STATE OF MARYLAND APPLICATION FOR PERMIT TO DRILL WELL

MEMORANDUM - Geothermal Wells

Re: **Geothermal Wells**
2227 Daisy Road, *Crawford property*

HOUSE LOCATION SURVEY
LOT 4, A RESUBDIVISION OF LOTS 1 AND 2
MARLIN G. FILLING PROPERTY
2227 DAISY ROAD 21797
ELECTION DISTRICT No. 4
HOWARD COUNTY, MARYLAND
SCALE: 1"=60' MAY, 1993

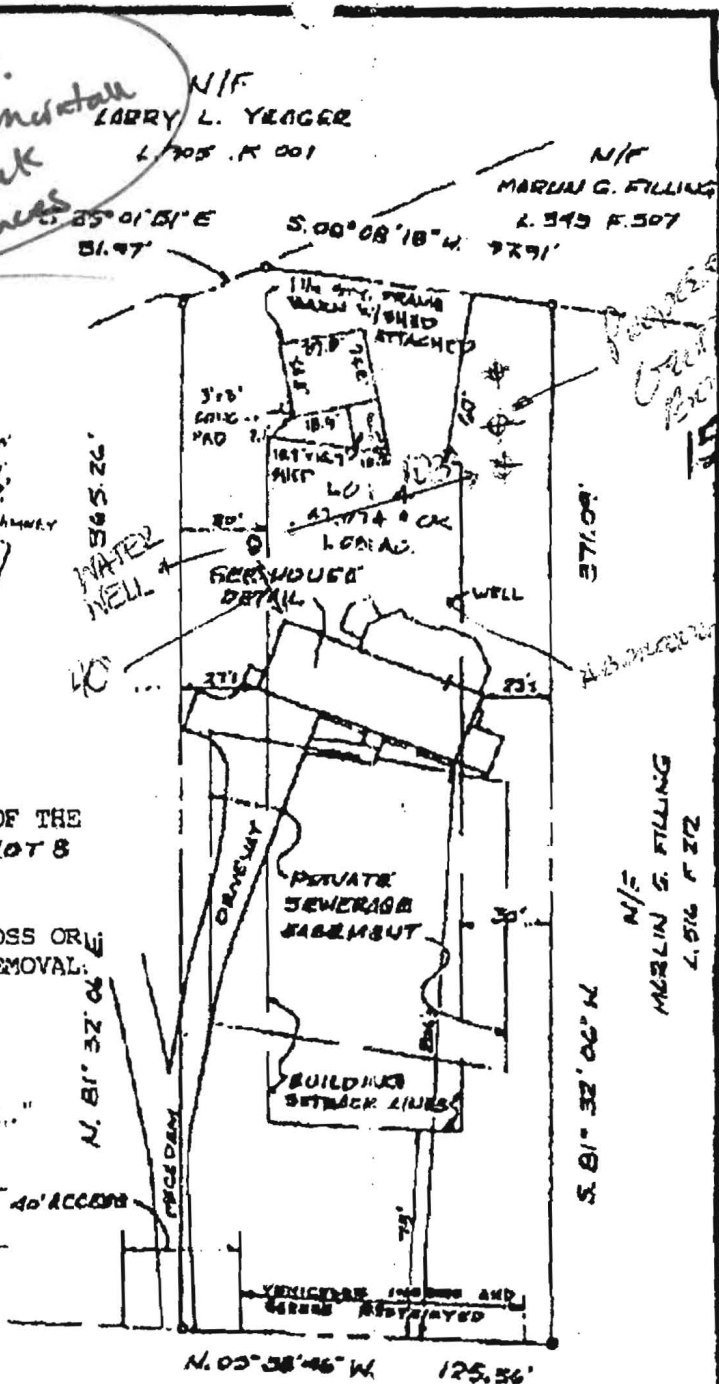
1) The **Site Plan** that shows nominal distances from features on the property to the geobores and indicates other pertinent features and structures on, or to be constructed on, the property needs to have the well shown and approximate location of the septic. Remember, setback distances are 30' from a well and 50' from septic components if bores are up gradient and 100' if down gradient of the septic.

OK.
Must maintain
set back
distances

4 TYPICAL BORE HOLE DETAIL
M1.00 NOT TO SCALE

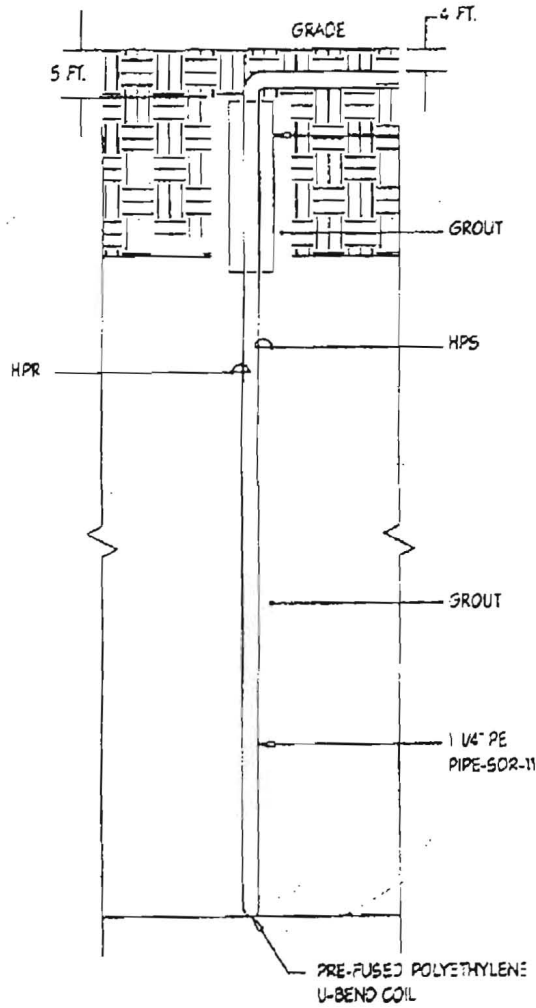
2) A **cross-sectional diagram** of the proposed geothermal well construction. Your statement of the intended grout mix is fine except that the mix needs to be grouted from the bottom to top. Not top to bottom. Please make these changes/additions and re-submit. Once this information has been received, the permit will be released.

OK
KW
